Staff Report
City of Richmond, Virginia

Commission of Architectural Review

3. COA-107855-2022	Final Review	Meeting Date: 4/26/2022
Applicant/Petitioner	John Vetrovec	
Project Description	Construct a new 2-story duplex with a roof-top deck on a vacant lot.	
Project Location		
Address: 313-315 N. 32 nd St.		
Historic District: Chimborazo Park		
High-Level Details: <ul style="list-style-type: none"> The applicant is proposing to construct a two-story duplex dwelling on a vacant lot. The units of the duplex will be divided vertically. The proposed dwelling features a two-story rear porch and a roof top terrace. 		
Staff Recommendation	Approval, with Conditions	
Staff Contact	Alyson Oliver, alyson.oliver@RVA.gov , 804-646-3709	
Previous Reviews	<p>This application was conceptually reviewed at February 2022 meeting. The Commission made recommendations on the overall height of the dwelling, expressing that an increase in height may be appropriate to relate to the existing dwellings on the block. The Commission also made comments in regards to the rear stair tower projection, suggesting a redesign that is less prominent.</p> <p>The application was also reviewed at the March 2022 meeting.

Figure 1. Vacant Lot. The proposed dwelling will be located on the southern (to the right) portion of the property.

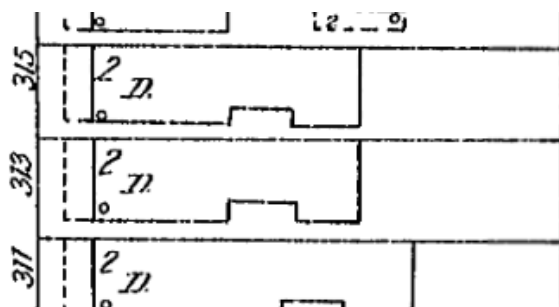
Guideline Reference	Reference Text	Analysis
Siting, #2, p. 46	<i>New residential infill construction should respect the prevailing front and side yard setback patterns of the surrounding block. The minimum setbacks evident in most districts reinforce the traditional street wall.</i>	An exhibit provided by the applicant indicates that the proposed dwelling will be setback approximately 14 feet from the property line, with the porch extending into the setback by approximately 6 feet. This is consistent with the setback of other dwellings found on the same block.
Siting, #3, p. 46	<i>New buildings should face the most prominent street bordering the site.</i>	The proposed dwelling is located along North 32 nd Street and will face the street accordingly.
Form, #1, p. 46	<i>New construction should use a building form compatible with that found elsewhere in the historic district.</i>	<p>The applicant has updated the plans since the February 2022 meeting to better complement the other dwellings found on the surrounding block. The front façade now features a faux mansard roof with a cross gable, which is compatible with neighboring buildings (see the “Street Elevation” exhibit provided in the application package).</p> <p>Staff also notes that the proposed design incorporates a rear stair element, which provides access to a rooftop deck. The stair tower, which originally projected above the roofline, has been removed. The rooftop terrace will now be accessed via a hatch. As a result of this modification, the only rooftop terrace element that may be visible from the adjacent right-of-way is the metal cable rail system.</p> <p>Staff notes that the folding door proposed on the north façade is not a typical element found in the district. However, finds that this feature is not prominent enough to detract from the overall design of the building.</p> <p>The applicant is proposing a detached garage at the rear of the dwelling. The proposed design is subordinate in size to the main dwelling and uses comparable materials. The simple shed roof design is compatible with other rear garages found in the district. <u>Staff recommends that the detached garage use a material and color palette that matches the principal dwelling. The garage should also use a simple garage door design that does not incorporate faux hardware. Final design to be submitted to staff for review and approval.</u></p>

Staff Recommendations	<p>Staff recommends the following:</p> <ul style="list-style-type: none"> The proposed lap siding be smooth and without a bead. Final material and color specifications to be submitted to staff for review and approval; The detached garage use a material and color palette that matches the principal dwelling. The garage should also use a simple garage door design that does not incorporate any faux hardware. Final design to be submitted to staff for review and approval; and Final design and material specifications for the proposed fence be submitted to staff for administrative review and approval.
